Appendix B.2
Agency Correspondence

Re: Class Environmental Assessment Study, Highway 50 from Castlemore Road/Rutherford Road to Mayfield Road/Albion Vaughan Road; and Mayfield Road, from Hwy 50 to Coleraine Drive

RE: NOTICE of PIC: Class Environmental Assessment Study Highway 50 from Castlemore Road/Rutherford Road to Mayfield Road/Albion Vaughan; and Mayfield Road, from Highway 50 to Coleraine Drive

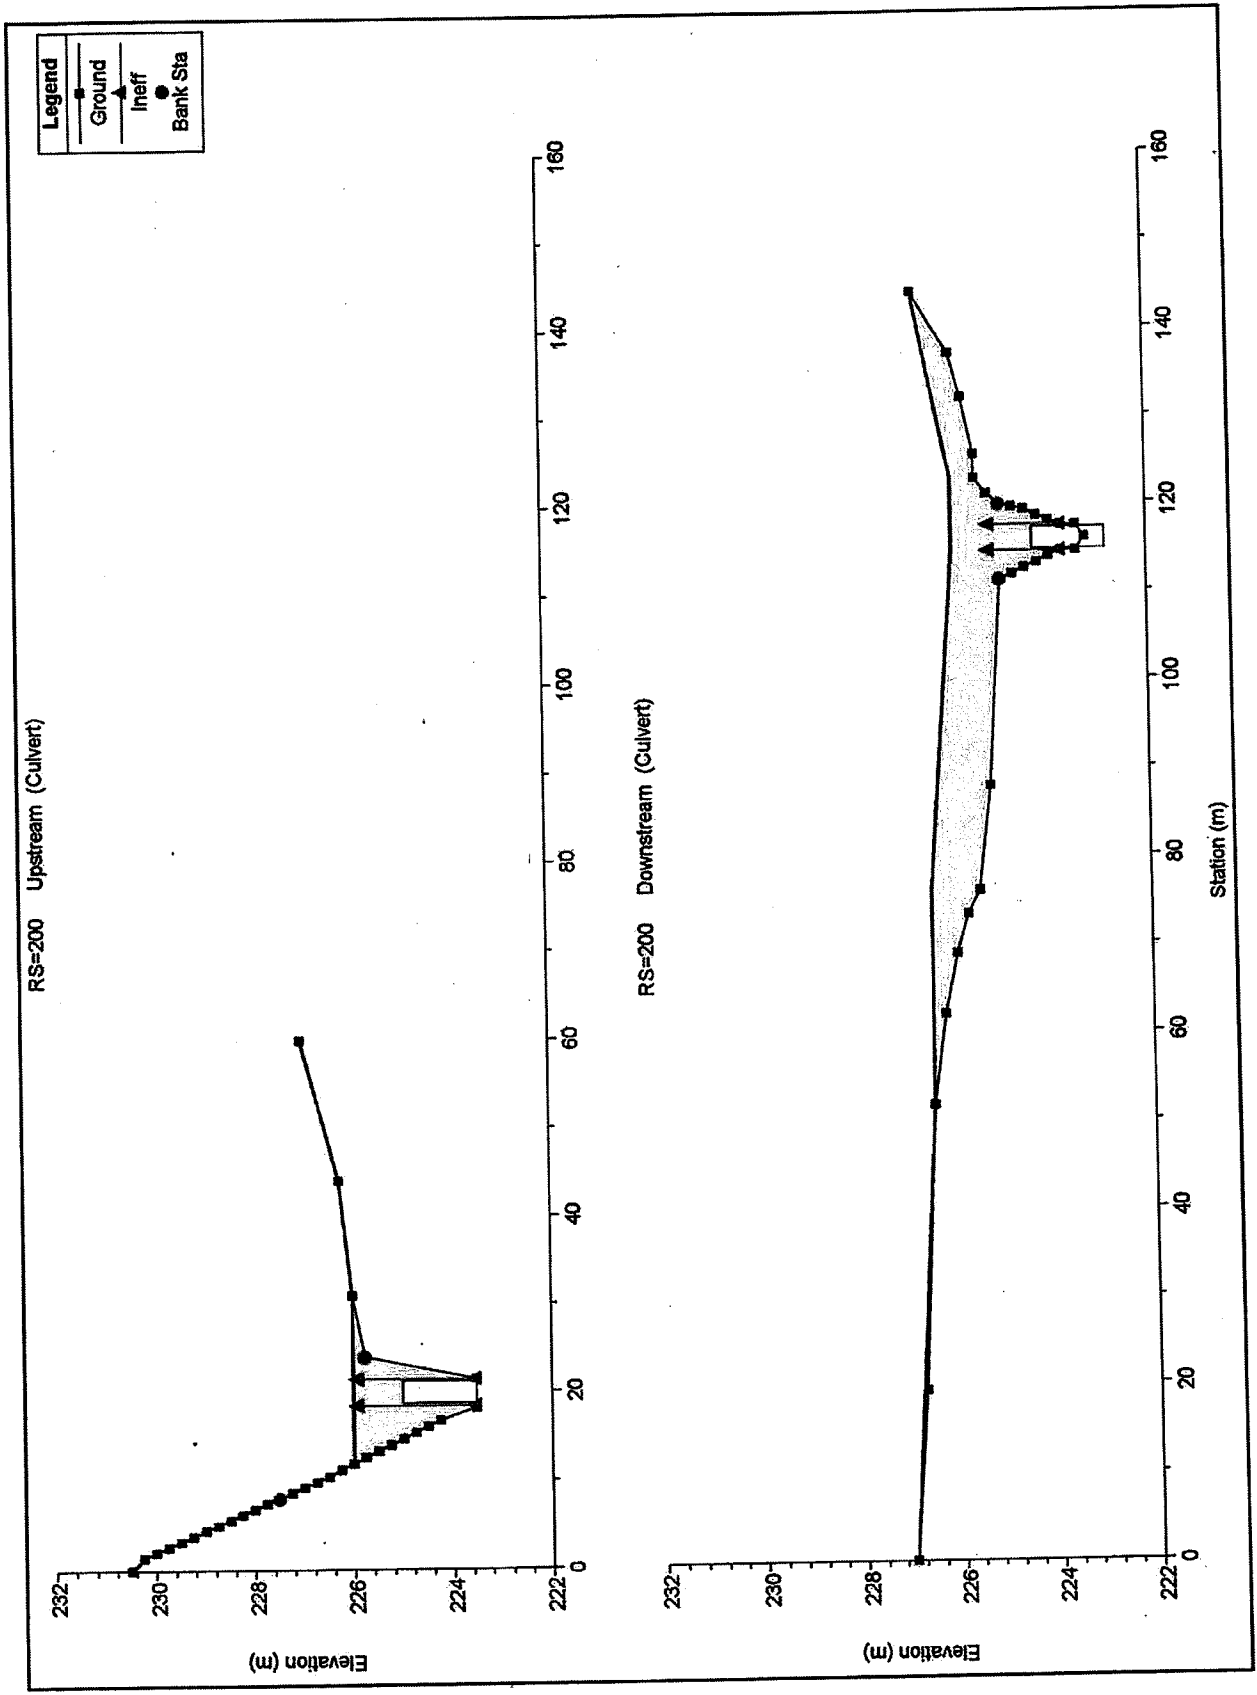
ITEM	TRCA COMMENTS (May 28, 2012)	HDR RESPONSE
Stormwater Management		
14.	Table 2-6 indicates that culvert 1 should be upgraded and ends reshaped and culvert 2 cleaned/flushed and ends reshaped. However, table 3-6 of the SWM report shows that these two culverts will be removed and replaced with a storm sewer. This should be clarified and text on table 2-6 adjusted accordingly. Crossings 1 and 2 were identified on site as watercourses and should therefore not be removed. Please provide an air photo outlining which watercourses require culvert replacements, extensions, and minor channel realignments, as currently this is unclear. In addition, section 6.4.12 Culverts and Structures indicated that culverts 1 and 2 will be abandoned, but they are associated with watercourses. Please clarify how the environmental effects will be mitigated. Currently, it is unclear how the watercourses are to be conveyed through the Hwy 50 right-of-way if the culverts are removed.	-

15.	As per the SWM strategy culverts 3, 8, 15, 17 and 18 do not meet the 1.0 m freeboard criteria. However the consultant recommends not replacing these culverts as they provide more than 0.5 m freeboard under the 50-year storm event. Text indicating replacement of culverts 15 and 17 should be removed from table 2-6, if this is the case. Staff deiers to the Region of Peel regarding the acceptance of a freeboard of less than 1.0 m.	-
Natural Features
